**Follow up Audit Question 16 Clarification  
on NRC NPSH question**

### **NRC Request for Additional Information:**

Figure 1 Callaway Cold Leg Recirculation Operating Mode

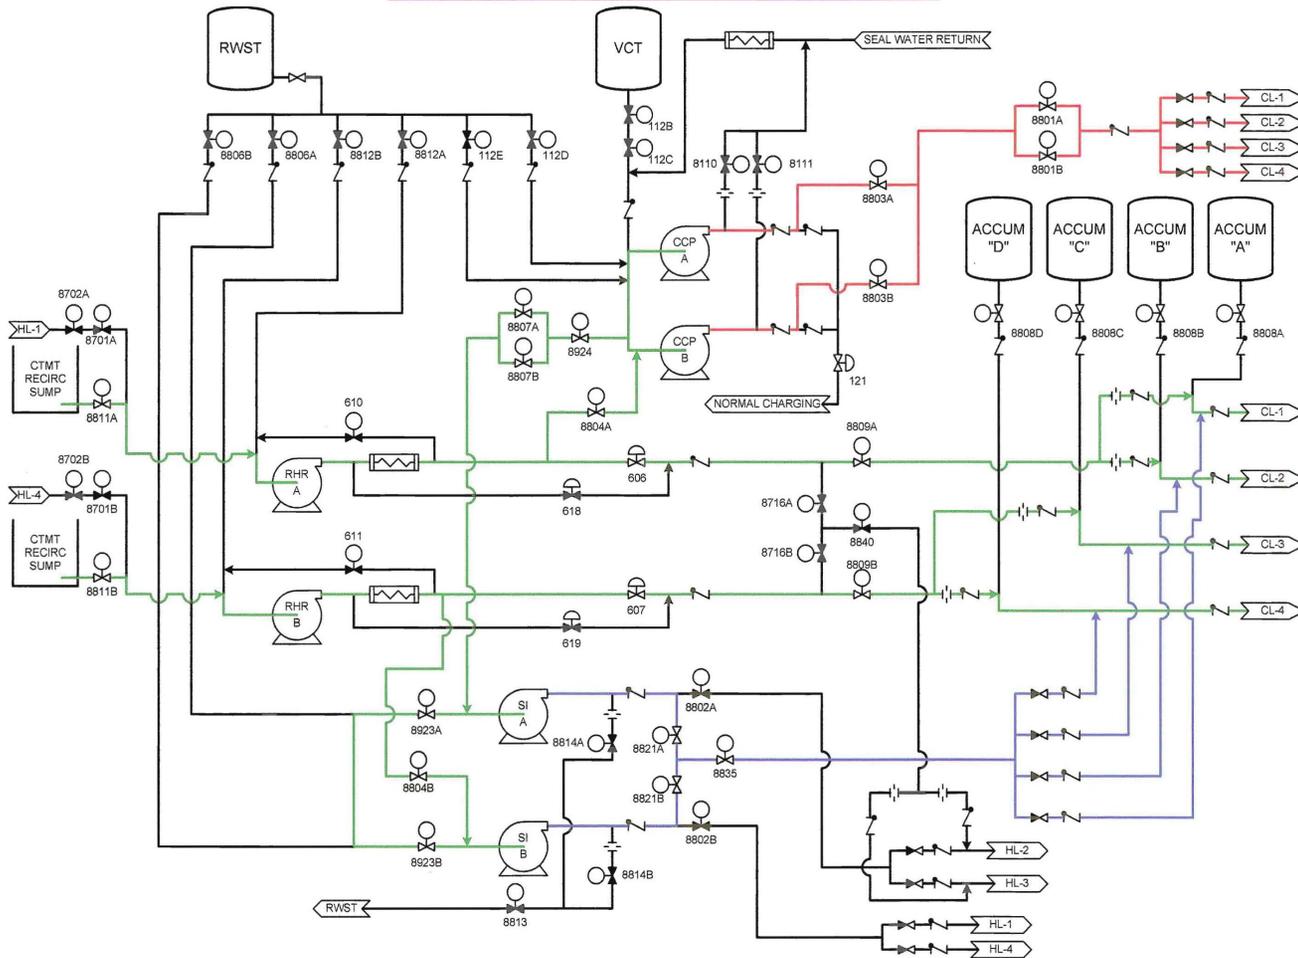
For the pumps that draw water from the sump during the loss-of-coolant accident (LOCA) recirculation phase, the sump temperature response and pump flow affects their available NPSH and required NPSH respectively. Provide the revised NPSH analysis, if exists, including containment accident pressure used to confirm positive NPSH margin for those pumps.

The RHR pumps operate in two different alignments when they draw water from the containment sumps: cold leg recirculation (*Figure 1*) and hot leg recirculation (*Figure 2*). At the end of the injection mode of operation, the system is initially aligned for cold leg recirculation. The limiting margin for available RHR pump NPSH occurs during the recirculation phase at the time of ECCS pump suction swap over from RWST to the containment recirculation sumps. The sump water elevation is at its minimum level since not all the emergency core cooling water sources [Refueling Water Storage Tank (RWST) and safety injection accumulator tanks] along with spilled reactor coolant system (RCS) water inventory have discharged and migrated to the containment sump. The acceptance criteria for this calculation is that the available NPSH shall exceed the required NPSH for the RHR pumps (Ref. "Net Positive Suction Head" section of FSAR SP 6.3.2.2).

The limiting RHR pump required NPSH configuration occurs when only one RHR pump is operating. In the limiting cold leg recirculation configuration, one RHR pump takes suction from the sump and delivers flow directly to two RCS cold legs and feeds two centrifugal charging pumps (CCPs) and two safety injection pumps (SIPs), both of which are injecting flow to the cold legs. In the cold leg recirculation configuration, both CCPs inject water into the RCS cold legs through a common header and both SIPs inject water into the RCS cold legs through a common header. This significantly reduces the maximum flow rate supplied by the CCPs and SIPs due to the increased hydraulic losses associated with shared piping and minimizes the required NPSH.
